August 13, 2021

Version 1

9" Center Display Buzz or Ticking Sound

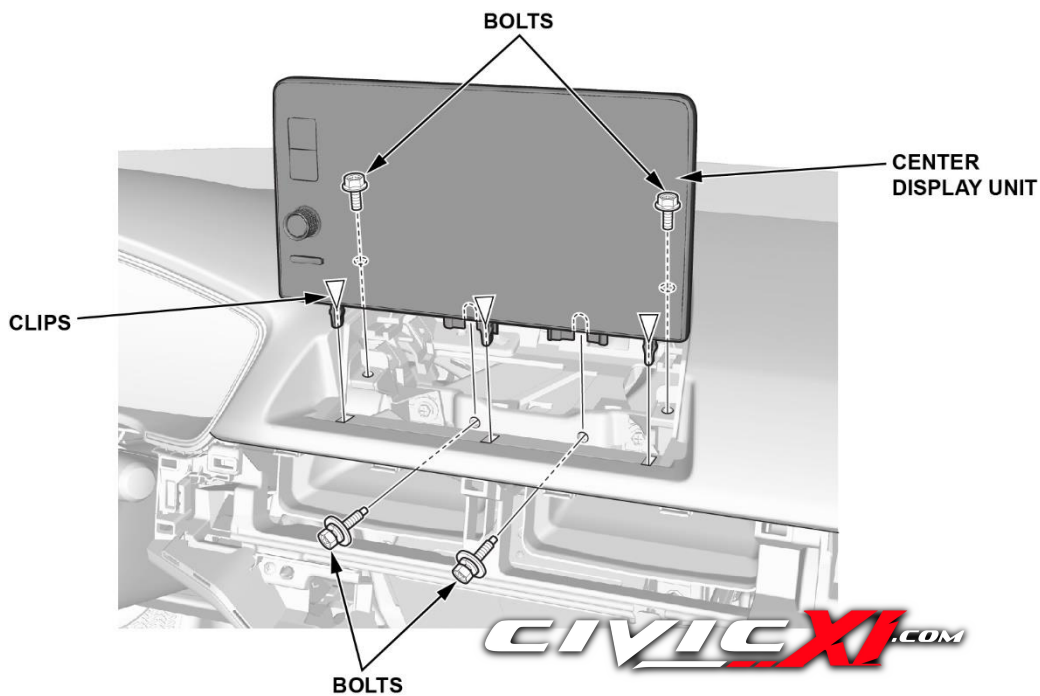
There is a gap between the center display unit and the dashboard causing vibrations.

Apply wool felt tape to the lower corners of the center display unit.

4. Apply 5 x 10 x 1 mm pieces of felt tape as shown in the location shown on both sides, then install the center display unit.

NOTE: Make sure the felt is not visible after screen installation.
